10' X 16' ORGANIZER

March 19, 2019

Re: Structural Certification
10', 12', & 16' Organizer Sheds

ROOF FRAMING

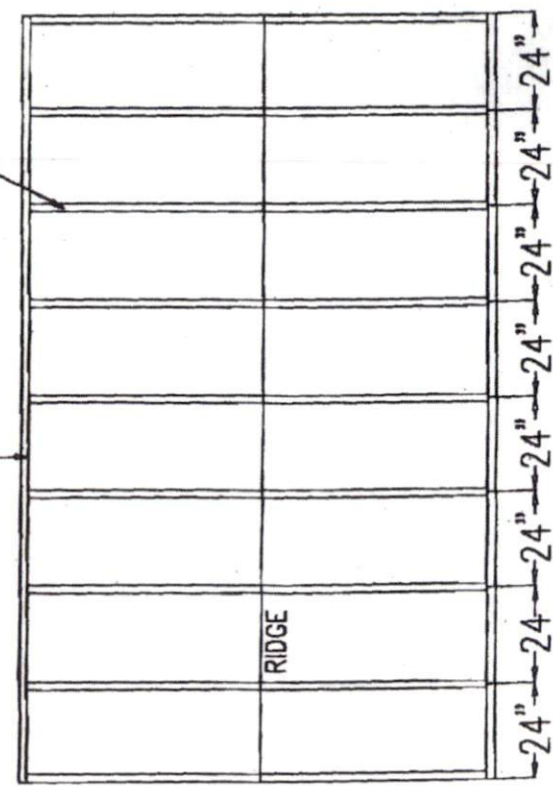
This variation consists of a 10' wide shed with a gable roof system. The roof consists of 2x4 rafters @ 2'-0" on center at either a 5:12 or 9:12 pitch, and the walls are constructed with 2x4 studs at 16" on center. Please be advised that the rafters shall be cross-tied with 2x4 collar ties located at the 1/3 point extending downward from the ridge and spaced at 4'-0" on center. The collar ties should be attached at each rafter with a minimum of (6) 10d nails

FLOOR FRAMING

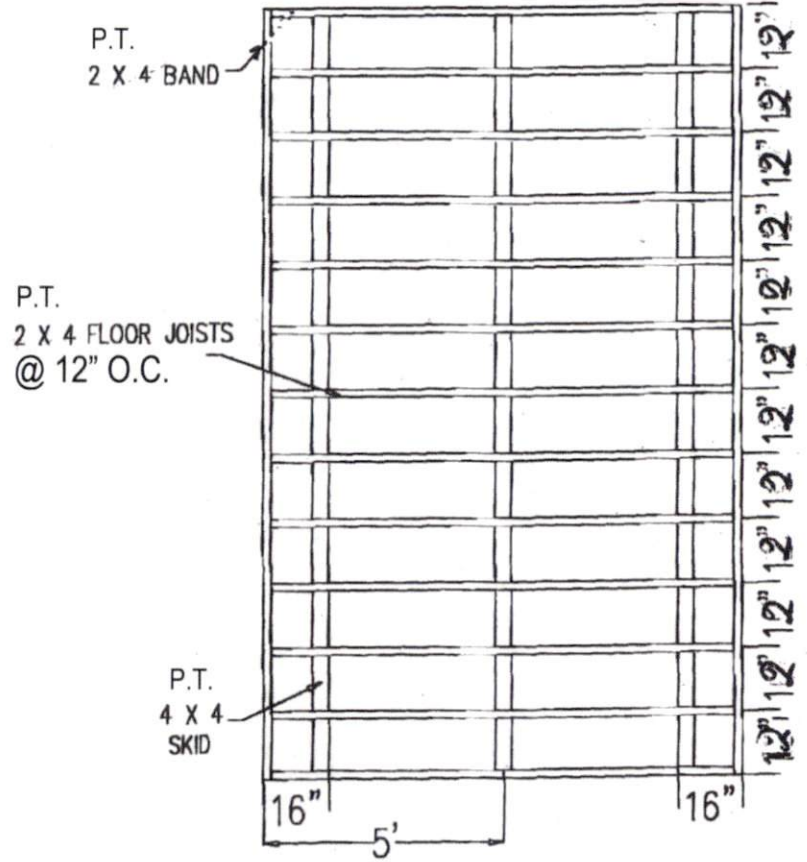
The floor framing consists of 2x4 joists at 16" on center supported on three (3) 4x4 "skids". Please be advised that the 2x4 floor joists can have a maximum of 10 1/2" cantilever beyond the 4x4 supports. Furthermore, please be advised that the 4x4 skids must be intermediately supported by piers at a maximum of 4' on center. Alternatively, if a double 2x6 beam is used for the skids, they must be supported at a maximum of 5' on center. The skids may bear on 8"x16" CMU piers which bear directly on the soil. The piers may be constructed with solid concrete masonry units top and bottom and hollow 8" concrete masonry units for the remainder of the pier at a maximum height of 36". The floor framing should be tied down with 30" screw anchors and 1" metal strapping across the floor joists.
